## United States Patent and Trademark Office

APPLICATION NO.	Fil	LING DATE	FIRST NAMED INVENTOR	ATTORNEY DOCKET NO.	CONFIRMATION NO
10/702,372	11/05/2003		Ming-Dou Ker	JC-7897-DIV	8473
23900	7590	11/29/2005		EXAMINER	
J C PATEN			STARK, JARRETT J		
4 VENTURI IRVINE, CA		230		ART UNIT PAPER NUMBE	
, <b>-</b>				2823

## **DETAILED ACTION**

FIG.7

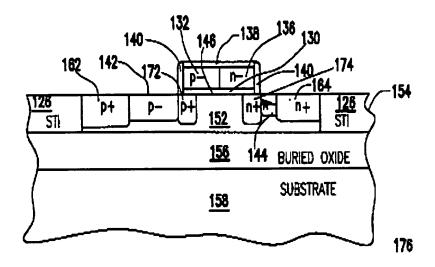
Claim 39 rejected under 35 U.S.C. 102(b) as being anticipated by Voldman et al. (US 6,015,993).

Regarding claim 39, Voldman teaches a method of forming a non-gate diode of a SOI, comprising:

providing a SOI with a substrate (<u>Voldman</u>, Figs. 7), an insulating layer (<u>Voldman</u>, Figs. 7, element 156) and a silicon layer (<u>Voldman</u>, Figs. 7, element 154) sequentially stacked together,

forming a pair of isolating structures (<u>Voldman</u>, Fig. 7, elements 126) in the silicon layer, so as to define a well region (<u>Voldman</u>, Fig. 7, elements 152) there between;

forming a first type doped region and a second type doped region in the well region and adjacent to the isolating structures (<u>Voldman</u>, Fig. 7, elements 162 & 164) .

Regarding claim 40, <u>Voldaman</u> teaches the method according to claim 39, wherin the first type and second type doped regions are implanted with P-type and N-type ions, respectively (<u>Voldaman</u>, Fig. 7, elements 162 & 164).

Regarding claim 41, <u>Voldaman</u> teaches the method according to claim 39, wherein the well region is lightly implanted with a P-type ion (<u>Voldaman</u>, Fig. 7, elements 142).

FIG.7

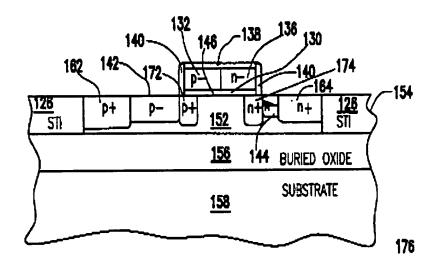
Regarding claim 42, <u>Voldaman</u> teaches the method according to claim 39, wherein the well region is lightly implanted with an N-type ion (<u>Voldaman</u>, Fig. 7, elements 144).

Regarding claim 46, Voldaman teaches a method of forming a non-gate diode in a CMOS process, comprising:

Providing a substrate (<u>Voldaman</u>, Fig. 7, elements 156) having a well region therein (Voldaman, Fig. 7, elements 152);

Forming a pair of blocking isolation structures in the substrate (<u>Voldaman</u>, Fig. 7, elements 126);

Forming a first type-doped region (<u>Voldaman</u>, Fig. 7, elements 162) located in the well region and between the blocking isolation structure, and

Forming a pair of second type doped regions (<u>Voldaman</u>, Fig. 7, elements 144 & 164) located in the well region and respectively adjacent to the blocking isolation structure (<u>Voldaman</u>, Fig. 7, elements 126), wherein each second type doped region is separated from the first type doped region by the well (<u>Voldaman</u>, Fig. 7, elements 152).

Regarding claim 47, <u>Voldaman</u> teaches the method according to claim 46, wherin the first type doped region and the second type doped region are implanted with P-type and N-type ions respectively (<u>Voldaman</u>, Fig. 7, elements 162 & 164).

Regarding claim 48, <u>Voldaman</u> teaches method according to claim 46, wherein the well region is lightly implanted with a P-type ion (<u>Voldaman</u>, Fig. 7, elements 142).
